Reviewers' Comments:

This paper reports the performance improvement of silicon single photon avalanche detector (SPAD); here the highlight is to employ a surface nano-texturing in order to utilize light trapping and reduce surface reflection. By doing so, they could get similar timing jitter but much enhanced photon detection efficiency (PDE).

Figure C-11 EQE angle dependent measurement when ϕ is 0° for 850 nm and 980 nm wavelengths. Measurement uncertainties are plotted as error bars for the repeated measurement.

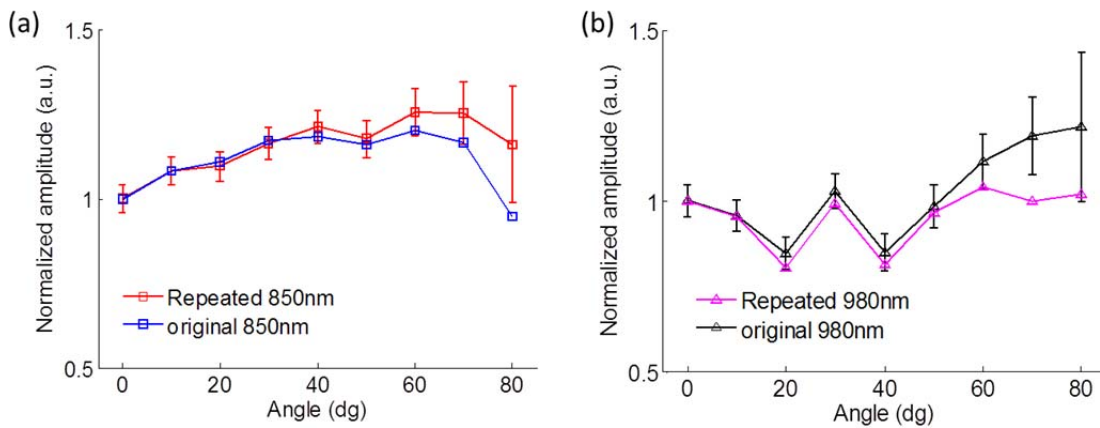
- Page 8, line 158: How long is the gate?
- Supplementary information: page 1, fig. S1 b: the measured data are pretty noisy, are they repeatable?
- The authors should revise the manuscript for correcting typos and English errors.

Thanks for your comment. Below we compare the results obtained recently with the data in the original manuscript (obtained 8 months ago). Fig C-11 shows consistent results. The large discrepancy at high injection angles may be from blocking or reflection of bonding wires in the original experiment and larger measurement uncertainties.

Figure C-12 Simulated device breakdown probability when a photon is absorbed in the depletion region, which is denoted by the two vertical dashed lines. Shaded area correspond to region being nano-structured.

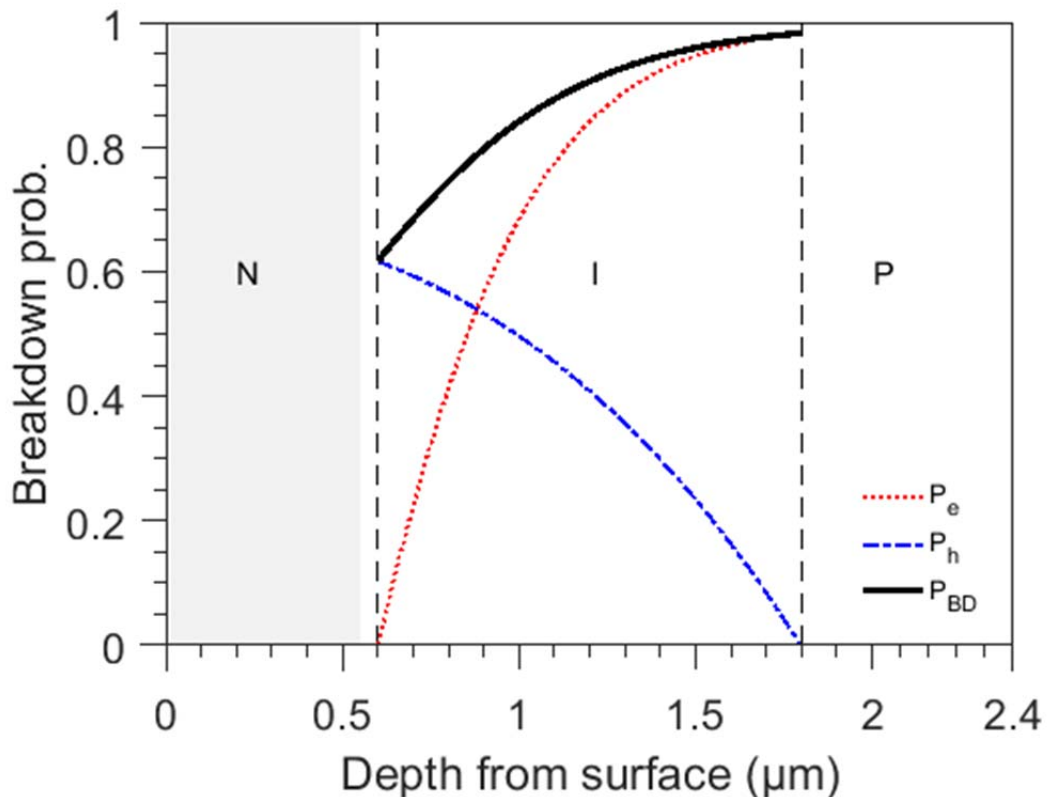
“In our design, the top layer is heavily phosphorus doped with holes as minority carriers and with a lower breakdown probability compared to electrons.” This is confusing, are the authors trying to say that there is a different avalanche breakdown for holes and electrons? This is either a badly written sentence or a very deep misunderstanding of the physics of the impact ionization process.

In Fig C-12, P_{BD} is lower at the N+ and intrinsic layer interface because holes have a lower ionization probability. Photons that are absorbed in the top N+ layer will only have a small chance to trigger the SPAD, which means they will contribute less to the jitter distribution. Although there is absorption difference in the top N+ layer between the light trapping and control SPADs, their jitter distribution differences are not as large. However, if we reverse the doping polarity, the difference between the jitter distributions will be more obvious because almost all the minority carrier electrons absorbed in the top P+ layer then will contribute to SPAD jitter distribution.

Figure C-13 Comparison of DCR between SPADs fabricated on an SOI substrate and a Si substrate.

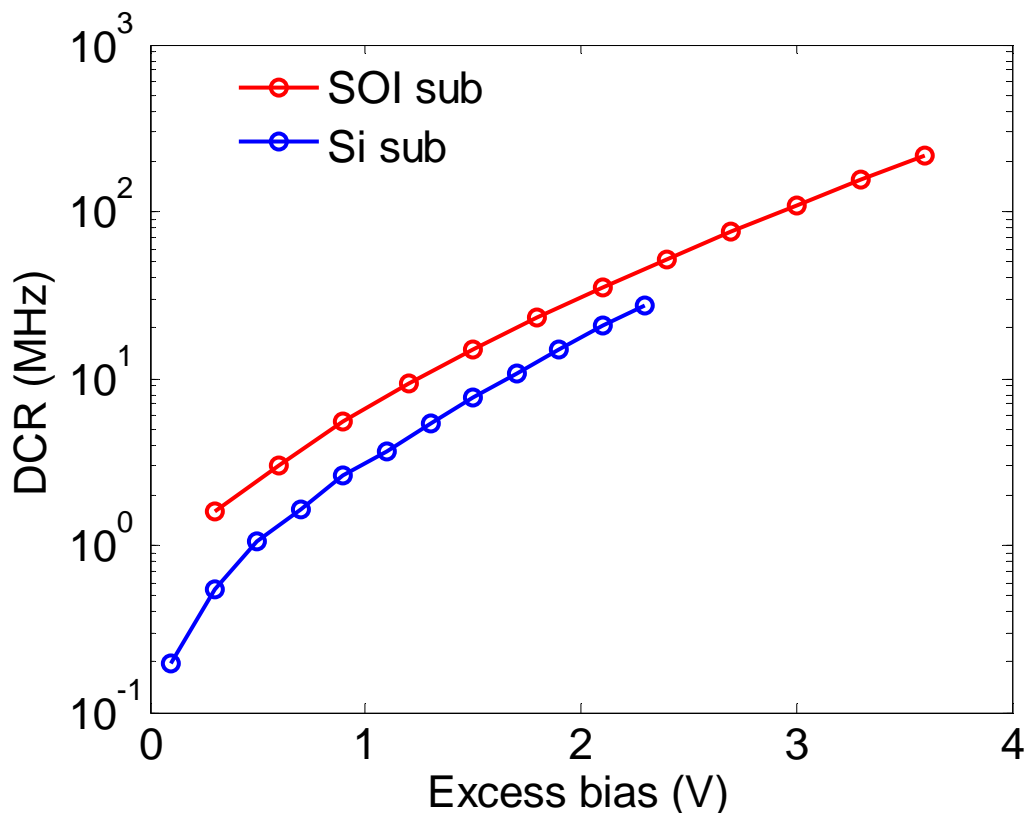
The DCR is 40MHz, which is exceptionally high for a silicon device, and will make measurement of SPDE very difficult. This is not mentioned. In fact, groups have shown even Ge-on-Si SPADs

Thanks for pointing it out. The high DCR is mainly due to the absence of a guarding ring structure in standard SPAD, which shall be the next goal of our research. Here, in the revised version, we used gated quenching configuration with a gate width of ~ 10 ns and a repetition rate of 1 kHz. This helps suppress the overall measured dark count rate. We agree with you that the high DCR of light-trapping SPADs is partly due to growth on SOI substrates. DCR comparison between SPADs on a Si substrate and on an SOI substrate is demonstrated as in Fig C-13. SPADs on the SOI substrate have almost double the DCR than those on the Si substrate. There is a difference, yet they are within the same order of magnitude.

Cooling measurements show that DCR decreases by 20% per 10°C, which suggests that there are tunneling breakdowns (e.g., trap-assisted tunneling breakdown) in the junction. We hypothesize that thin-junction SPADs of ~2 μm thickness often suffer from tunneling-related DCR due to narrower depletion widths. Similar phenomena can be found in Ref [5], [6].

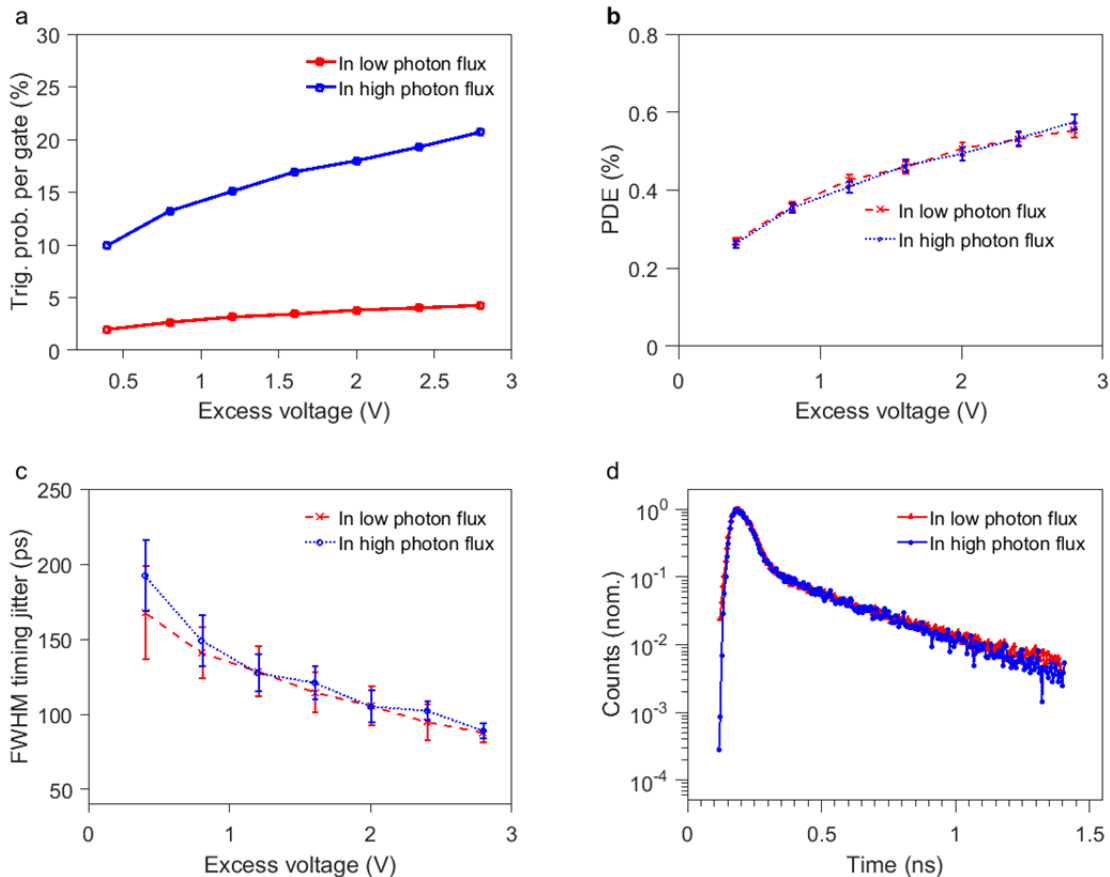
My main concern regards the impact of high photon fluxes on PDE and time jitter measurements. The straightforward method, followed by all the researchers working in the SPAD field, is to use the TCSPC (Time-Correlated Single-Photon Counting) technique and to limit the count rate in order to avoid distortions in the reconstructed waveforms. In detail, a rule of thumb is to limit the start-to-stop ratio in TCSPC measurements to 5% in order to have a distortion of less than 1%. This guarantees correct PDE and timing jitter estimations. Therefore, I think that the corrections described in appendix I and II of the rebuttal letter have to be avoided by acquiring the optical waveforms with low count rate. This is possible even when DCR is pretty high by working in gated mode in order to limit the impact of high DCR.

However, it is not practical to achieve this goal due to the current high DCR of 40MHz, even by working in gated mode as kindly suggested by the reviewer. Gated mode measurement with a 10ns gate width has already been performed in our previous tests. The minimum gate width is 2ns, due to the jitter distribution of the light trapping SPAD. At 2ns gate, we will still have a trigger probability of 8% to detect a dark count.

Therefore, in PDE and jitter distribution measurements, we have to use gating technology and the corrections described in appendix I and II in the previous response letter. The corrections are based on a basis that the properties of the input light in a SPAD characterization are stable and can be well known, thus the multi-photon effect and pile-up effect can be well corrected, which is different from many other TCSPC applications. Here, we have conducted some comparative experiments over several excess voltages to further prove the reliability of our characterization method. A thicker-junction SPAD mentioned in the previous response letter is chosen with a DCR of about 1MHz. It is measured under a gated width of 10ns (1% trigger probability for dark counts), first in low photon flux with total trigger probability following the 5% rule without any corrections, and then in high photon flux with corrections described in the appendix I and II in the previous response letter. The results are shown in **Figure 1**.

It should be pointed out that the structure of thicker-junction SPADs in the comparative tests are different from the light-trapping one. There is no strong light trapping so absorption is terrible at 940nm wavelength. Therefore both the PDE (due to absorption) and jitter performances (due to thicker junction of 3.5 μ m) are poor. However, this does not affect the comparisons of measurements in low or high photon flux. As shown in **Figure 1 a**, the trigger probability per gate in low photon flux are well below 5% over all tested excess voltages, thus the PDE or timing jitter estimated in low photon fluxes in **Figure 1 b, c, and d** have a distortion of less than 1% based on the rule of thumb. If we increase the photon flux so that the trigger probability per gate reaches 20% as shown in **Figure 1 a**, which is similar to the scenario when we characterize our light-trapping SPAD in the manuscript, the distortion will be quite large. However, as shown in **Figure 1 b, c, and d**, after applying the corrections described in the appendix I and II in the previous response letter, the estimated PDE and jitter distribution in high photon fluxes match very well with the results from traditional low photon fluxes.
